## **Fisheries and Oceans Canada**

### Information Requests

### Final Environmental Impact Statement and Supporting Documents

### **Mary River Iron Ore Project**

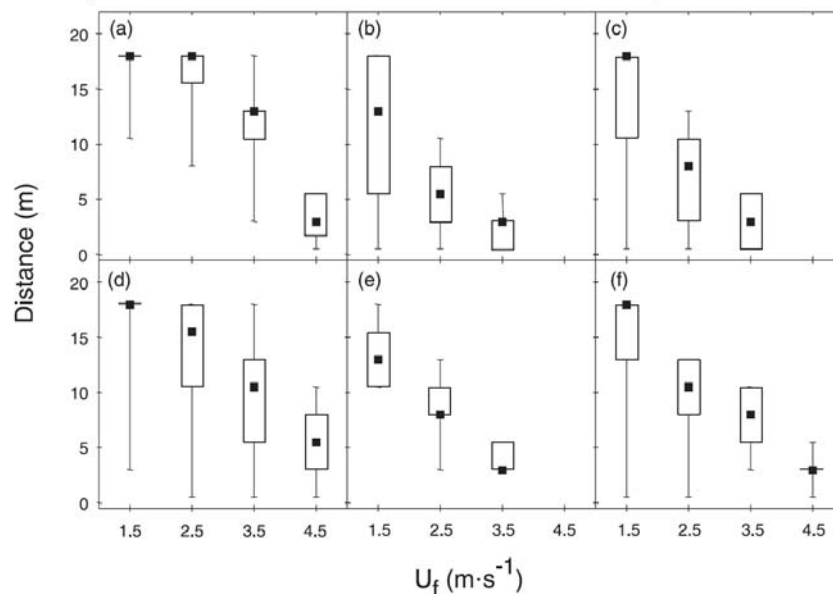
Haro et al (2004) measure the swimming distance against a series of water velocities for six (adult) migratory fish species using an open channel. Results for the test are summarized in Fig. 4, and show the median and 95 percentile swim distances were 10 m and 15 m or less, respectively for the water velocity of 2.5 m/s for 4 of the 6 species (alewife, blueback herring, walleye and white sucker).

Passage estimates summarized in Table 7-4-10 show partial impediment to fish passage for juvenile Arctic char for water velocities of 2.5 m/s and culvert lengths of 40 m or less which is significantly higher than the measurements from Haro.

A more realistic estimate of performance for juvenile Arctic char would be to reduce the culvert lengths in Table 7-4.10 by half for corresponding culvert flow velocities, with <40 m becoming < 20 m , 40-60 becoming 20-30 m etc.

- Using the recommended swimming distance correction (reduce distance by half) for Table 7-4.10, please provide an update on how this change will affect the fish passage and HADD assessments.
- DFO requests that the proponent provide the methodology used for the collection of the flow data at culverts along the Tote Road; the flow data which was collected and how the average flows for each culvert were calculated.
